ARCHITECTURAL REVIEW BOARD MEETING

2. COA 26-22: 10 Hotel Street

STAFF REPORT

Meeting Date:	August 27, 2026
Agenda Title:	COA 26-22 10 Hotel Street
Requested Action:	Proposed Rear Addition, Exterior Alterations, and Landscaping Improvements
Department / Agency Lead:	Community Development
Staff Lead:	Whitney Burgess, Preservation Planner

01 SECTION DETAIL - ADDITION PARAPET
3/4" = 1'-0"

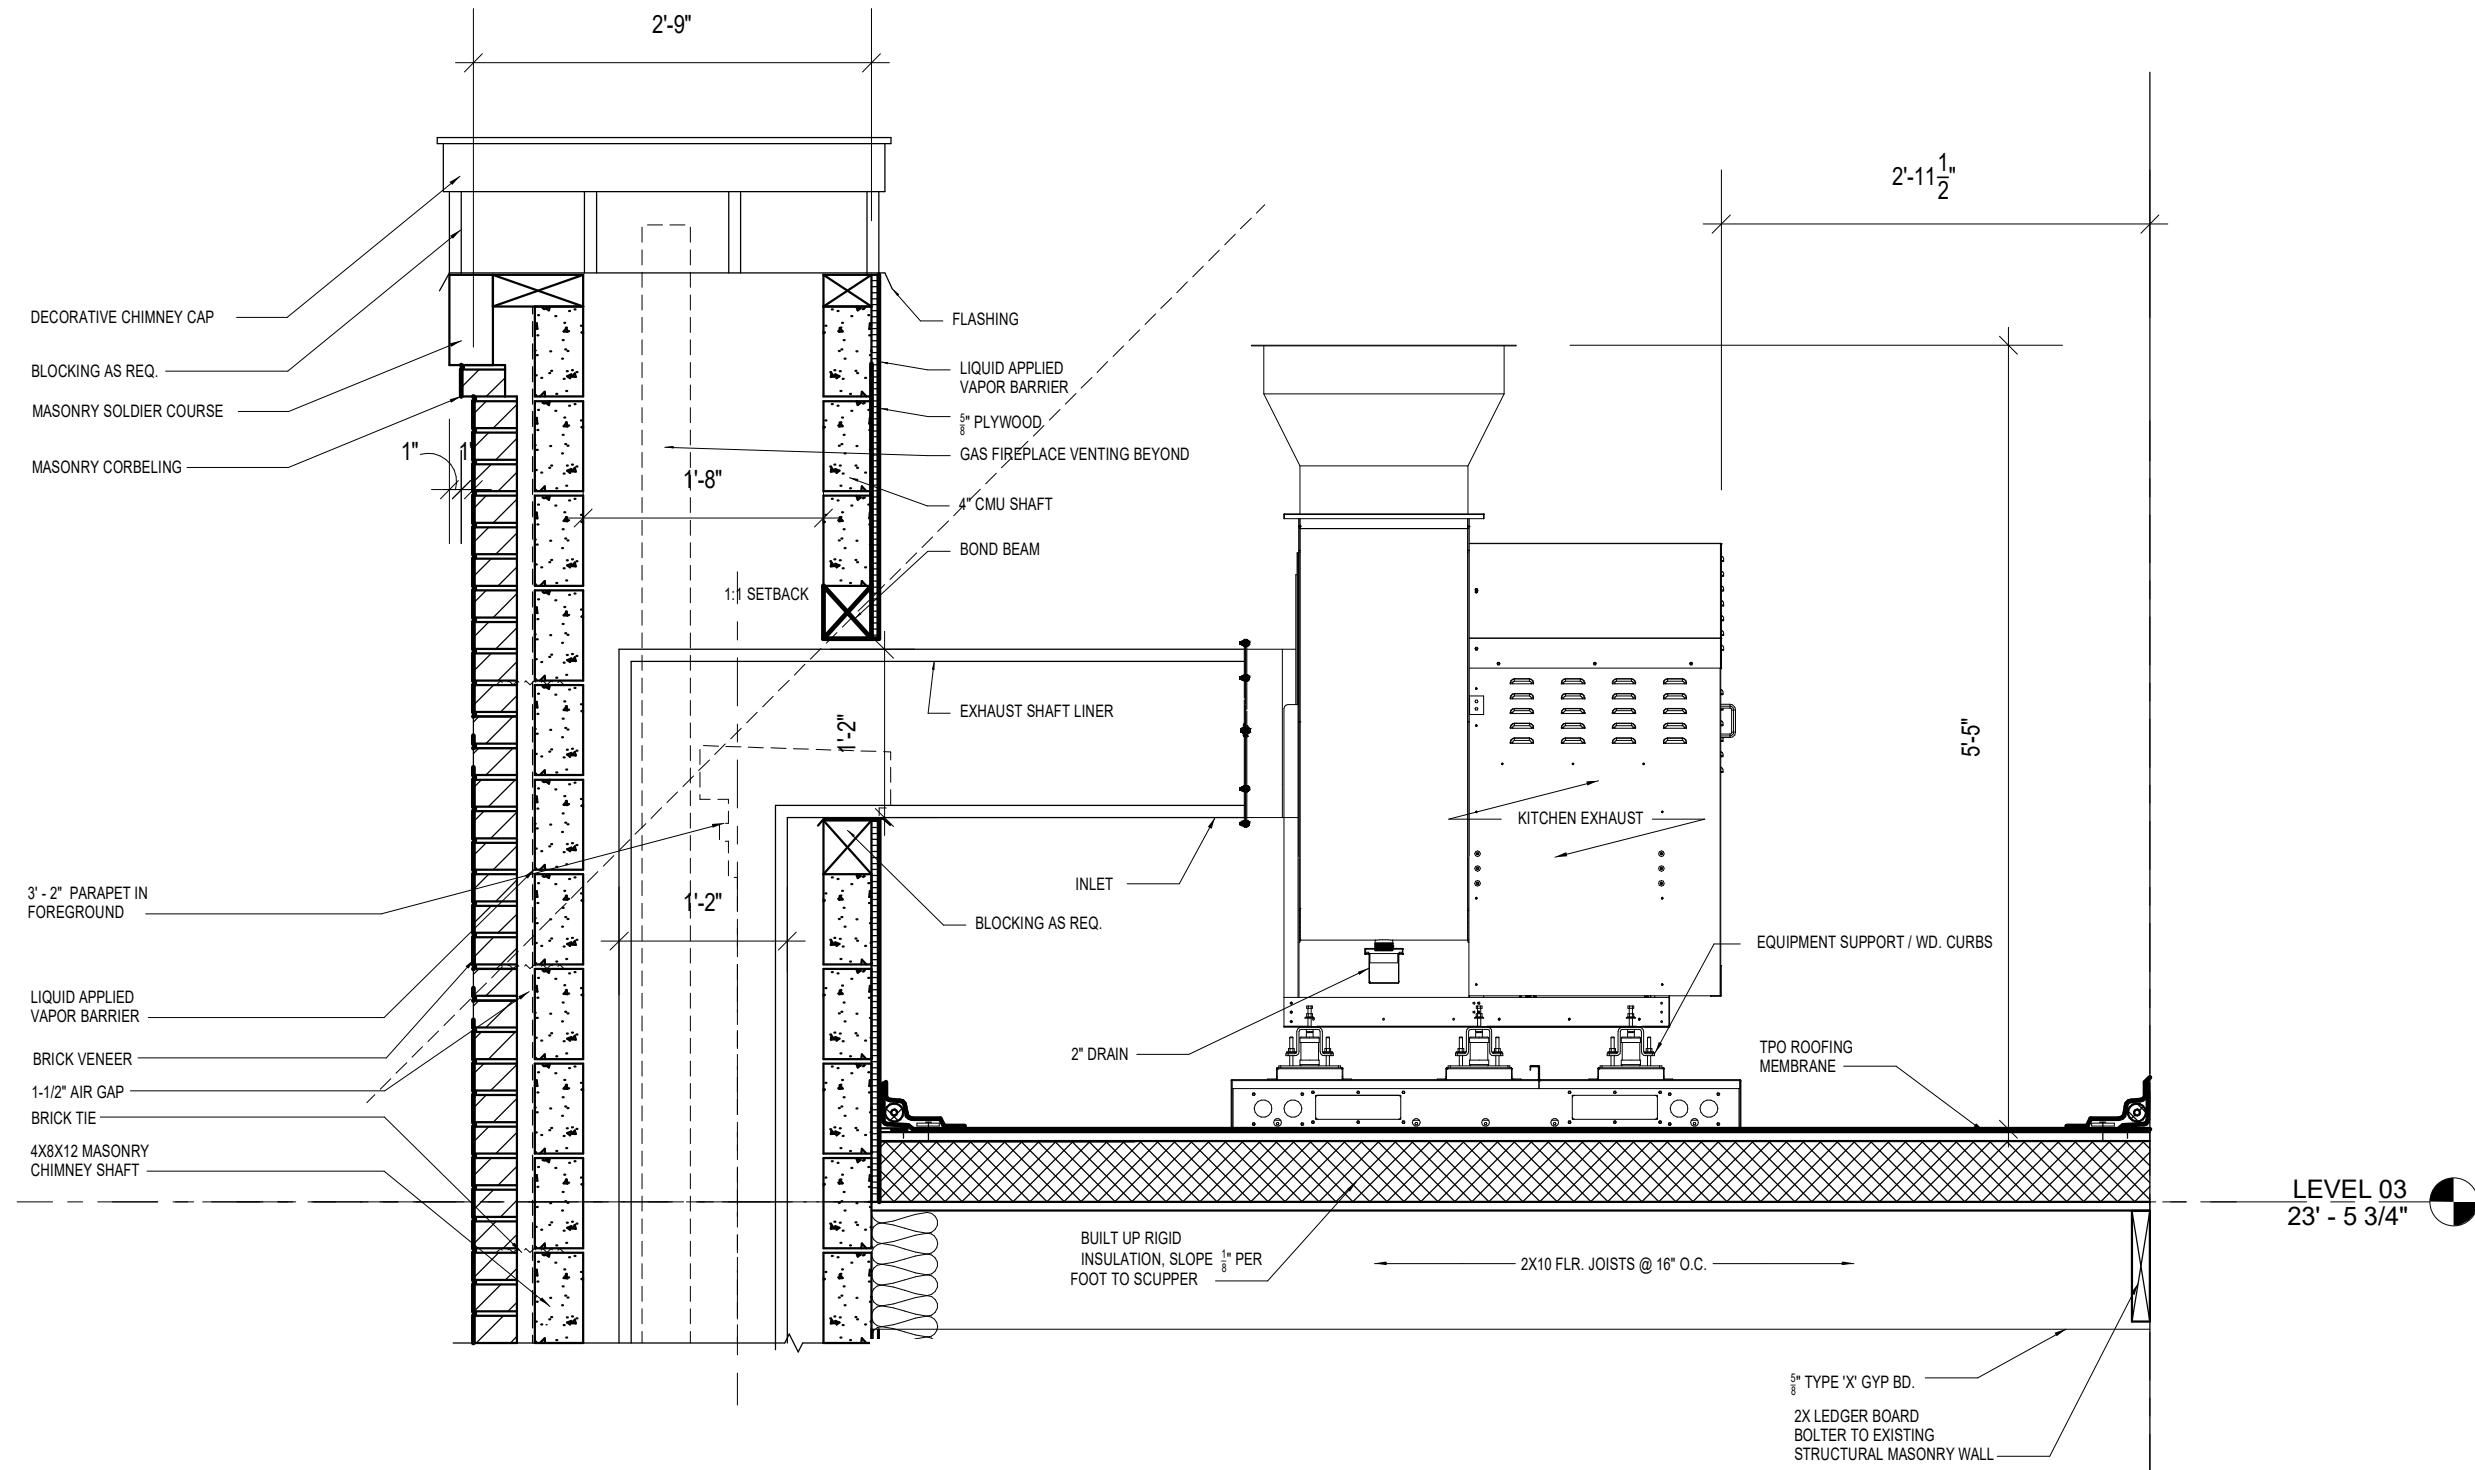
Chair Beidler asked for clarification on the roof structure and the mechanical screening and the parapet dimensions. A taller parapet may be more appropriate.

Mr. Scoggin asked the board for clarification on what the recommendation for the parapet and chimney heights should be for the record.

A height of 3 foot was suggested.

The applicant agreed a taller parapet would work and the height could increase to three feet.

The applicant agreed that three feet in height is appropriate.

- 5) The proposed new roof mounted equipment should be fully screened from the centerline of the east sidewalk along Culpeper Street; and
- 6) Any new plantings, as part of proposed landscaping changes, should be planted or contained with vegetation at least 4 inches away from the exterior walls; and

01 DETAIL - KITCHEN EXHAUST AT ROOF
3/4" = 1'-0"

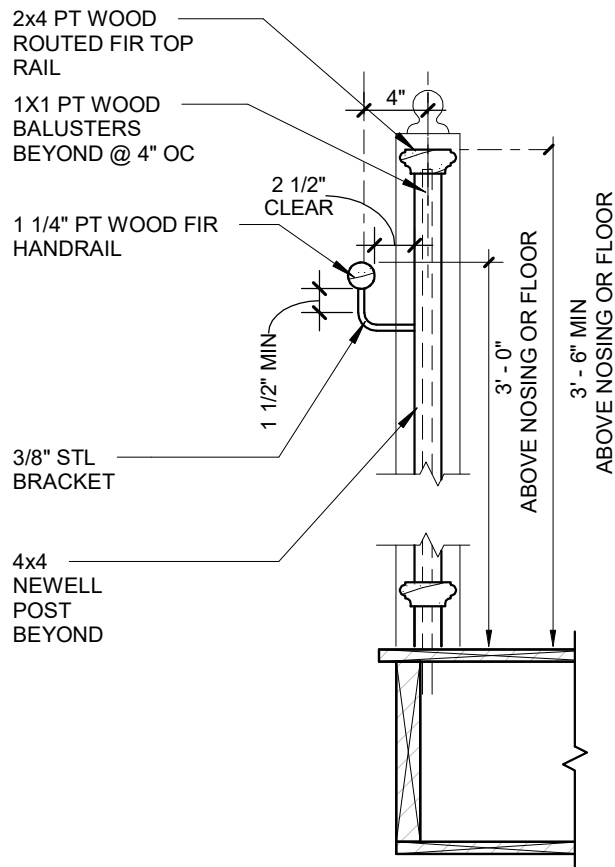
The applicant discussed ways to hide the utility equipment for kitchen (grease duct and fan) behind the chimney.

Chair Beidler asked for clarification on the utility plan inside and around the chimney.

The applicant explained the utility plan and agreed to update the designs to show the correct ductwork behind and within the chimney.

01 SECTION - FRONT PORCH STAIR
1/4" = 1'-0"

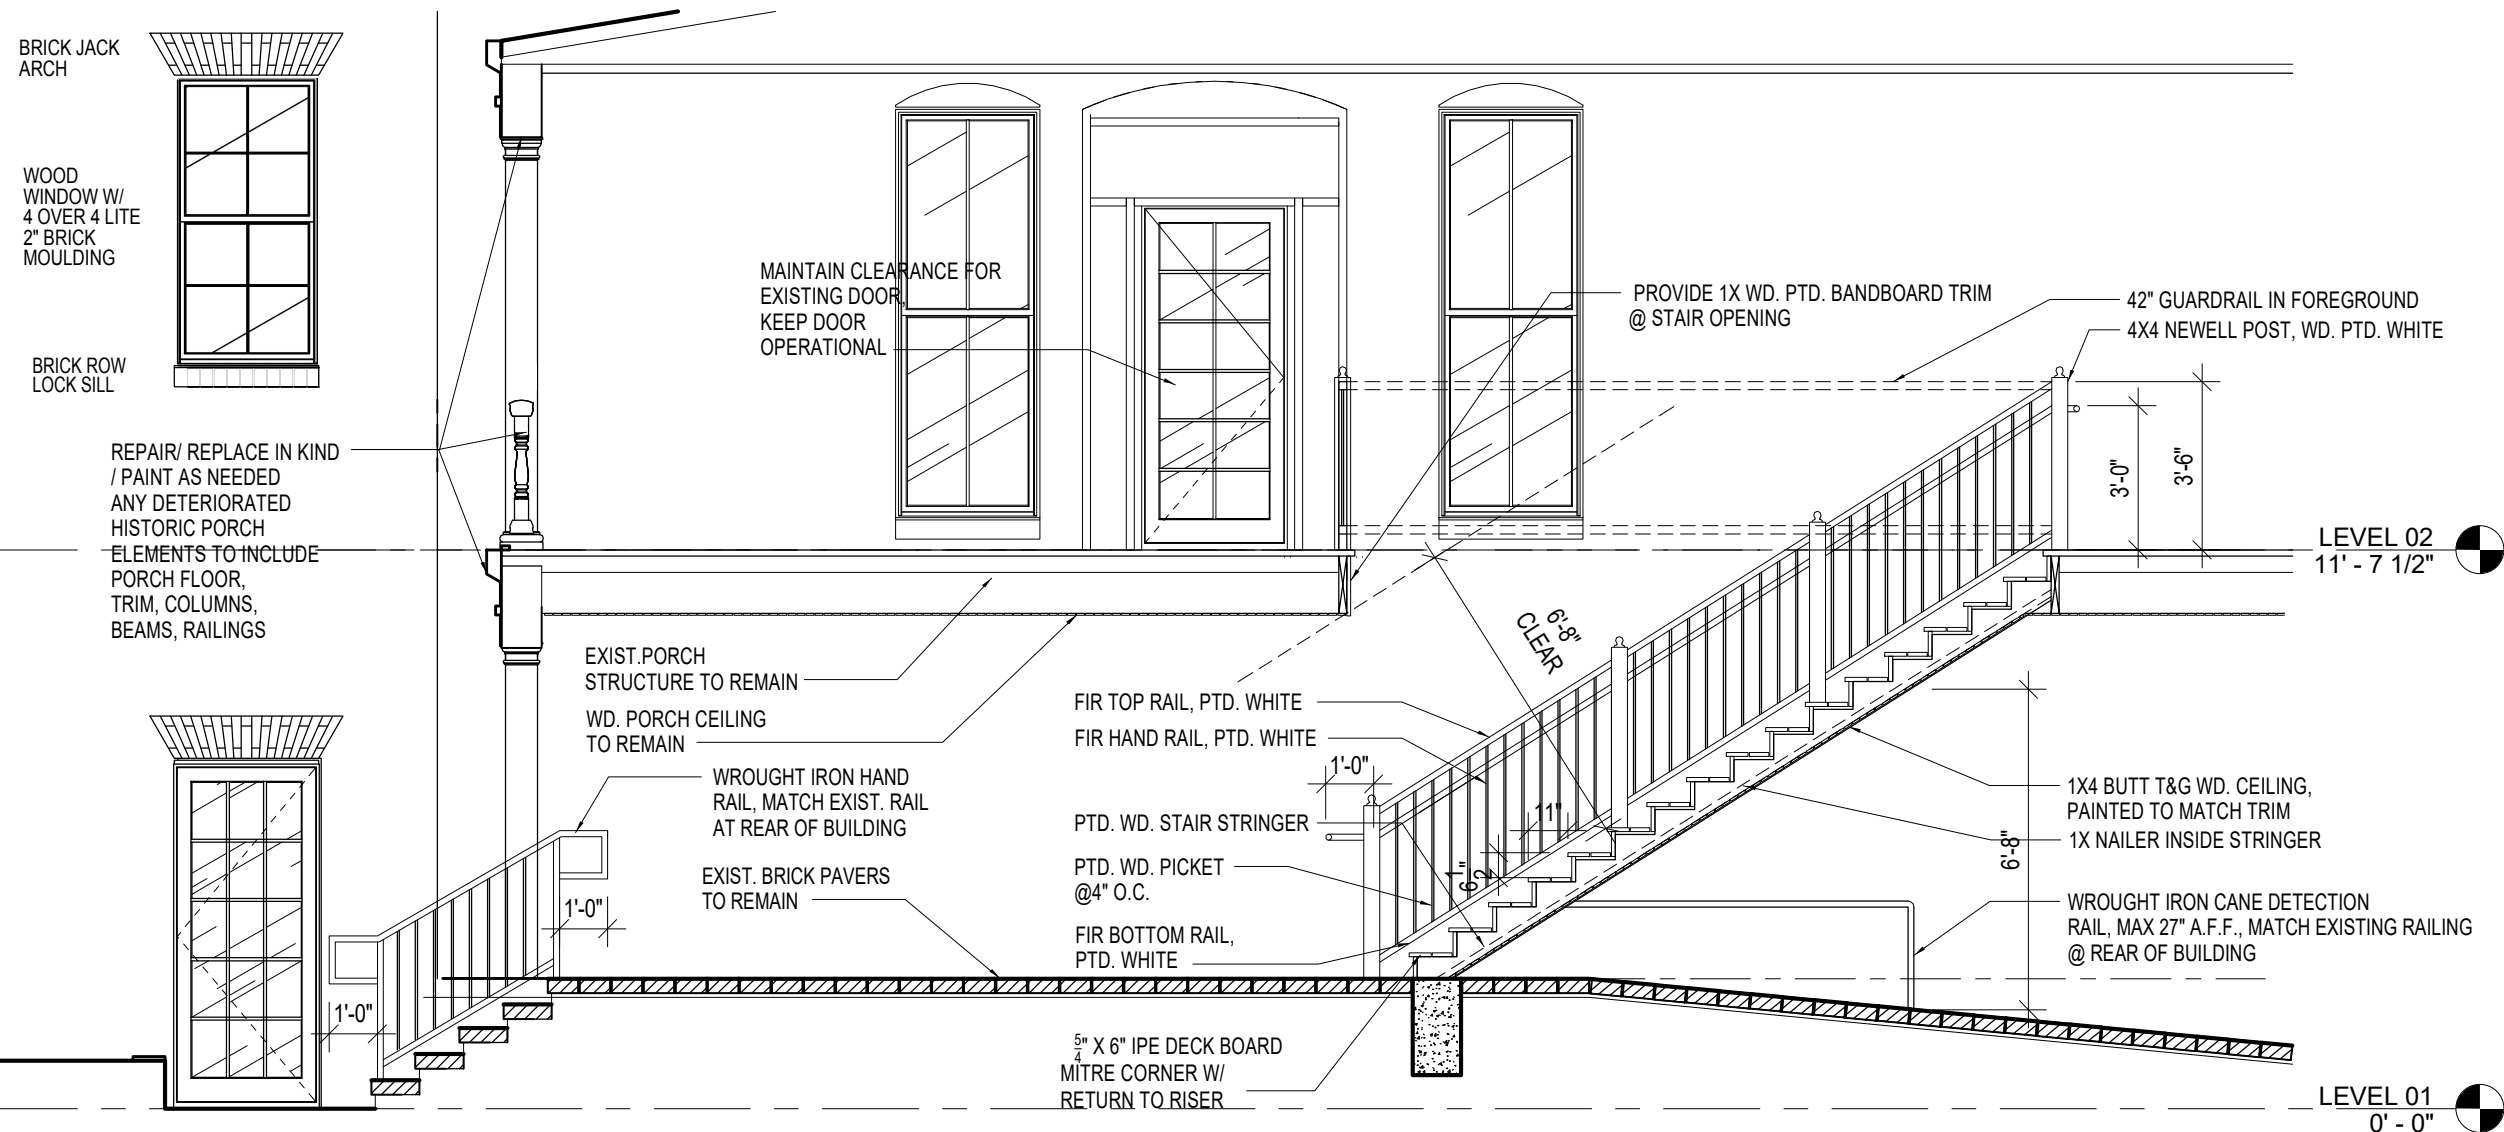
Chair Beidler asked for further details on the stair construction.

The applicant discussed details of their design choices and asked the board's preference on the porch cutout for the stairs

Chair Beidler asked the applicant to update the plans to provide further details on the porch alterations and repairs and recommended a condition of approval excluding any potential porch repairs and stair construction from this review.

The applicant agreed to modify the plans to explain the porch details and have a structural engineer verify the feature is structurally sound.

- 3) Retain, repair, and preserve original wooden porch details where possible. Any materials deteriorated beyond repair should be replaced in-kind. Substantial alteration to porch design would require a new COA and further ARB review; and

Originally proposed signage and lighting:

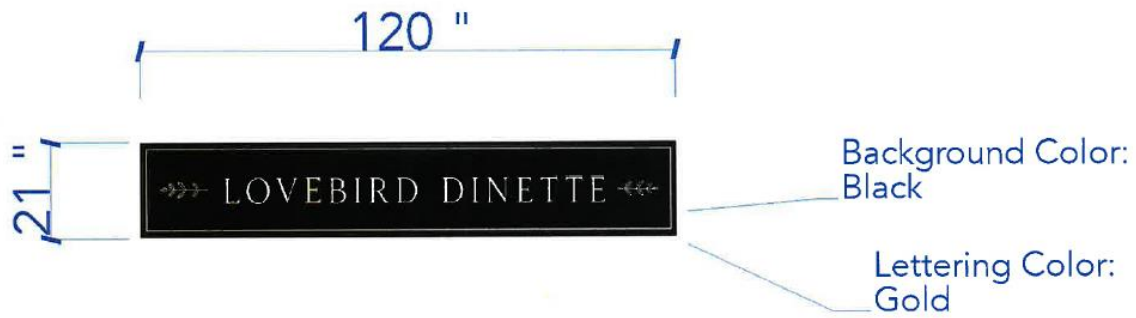
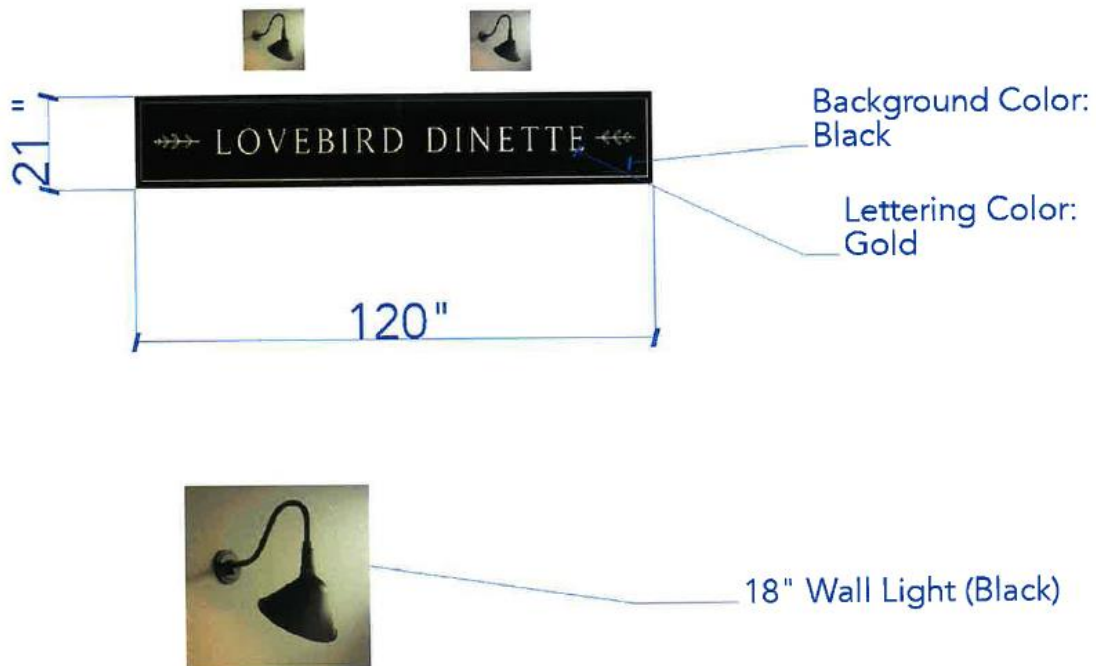
Feedback from Zoning Staff:

Building Sign

Additional information is required for review of the building sign. Provide the width of the façade for the tenant space, AND provide location and size information for all other signs mounted on the front of the building that faces Main St. The total area of the building sign cannot exceed 1.5 sq.ft. per façade width, OR 132 sq.ft. for the entire building wall that faces the street, *whichever is less*. The proposed sign equals 17.5 sq.ft. (Z.O. 6-13.3.5)

Staff recommends the desired wall sign is scaled down to meet those same dimensions as the neighboring unit at 77 Main Street, which measures 88" in width and 15" in height. This would also prevent the inlaid diamond detail from being covered. The style and accompanying lighting meets HD Design guidelines. All attachments should be affixed at the mortar joint so as not to impact historic brick.
